Permit Amendment

T-14514

REFERENCE: Permit Amendment Application T-14514

In the Matter of Permit Amendment) FINAL ORDER
T-14514, Baker County) APPROVING A CHANGE IN PLACE OF USE

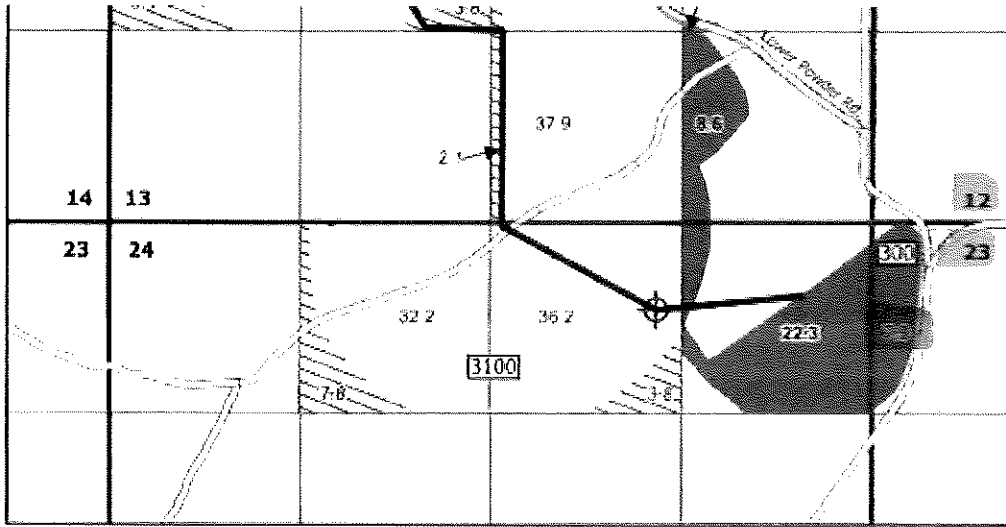
I tried calling your cell phone but the voicemail is full and I wasn't able to leave a message. 😊 I have completed the processing and review for T-14514 (John and Susan Dunlap). and am ready to issue the final order to approve the permit amendment however, there is a discrepancy we have found during our review of the Permit Amendment.

Table 2 and the map show that there are 7.9 acres of "TO" lands located in 8S 41E Section 23. However, both the map and the table are incorrect. The 7.9 acres as it is shown on the map is actually located in 8S 42E section 19. I am setting a deadline of October 22, 2025 for a response from you to submit a corrected table and map or to withdraw the application. If you have any questions or need additional time, please let me know.
